UNITED STATES PATENT AND TRADEMARK OFFICE

09/729,443

Office Action Summary	Application No. 09/729,443	Applicant(s) JAFJE ET AL.	
	Examiner JUAN A. TORRES	Art Unit 2611

DETAILED ACTION

Fig. 4. Delay influence on tentative decisions (TD) reliability.

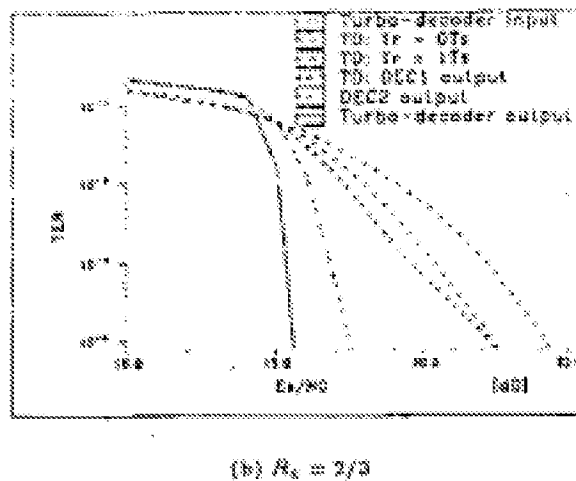
The Examiner disagrees, and asserts that, Mottier discloses in section 3.1 specifically that "Therefore, the mean BER of the bit sequence used to build a symbol tentative decision $d(k)$ depends on the BER of the bit tentative decisions extracted from DEC1 and on the BER before decoding, each weighted by a coefficient depending on the puncturing matrix. The BER. of the bit tentative decisions issued from DEC1 is presented FIC.4 for a 64-QAM with $R_e = 1/2$ and $2/3$ coding rate. Tile curves are plotted for different values of symbol delay. Regardingformance reference, the BER curve after 1 iteration of Turbo-decoding is presented"

Figure 4b shows performance for a delay of zero $T_r=0$ T_s , so in fact Mottier is disclosing a Viterbi decoder with delay zero, so it is a Viterbi decoder that doesn't depend of future values of the signal. In section 3.2 "Delay insertion" Mottier also discloses that the values for $T_r=0$ are possible (see equation 5)

So it is clear from this presentation that the reference of Mottier clearly anticipated the idea of the present invention.
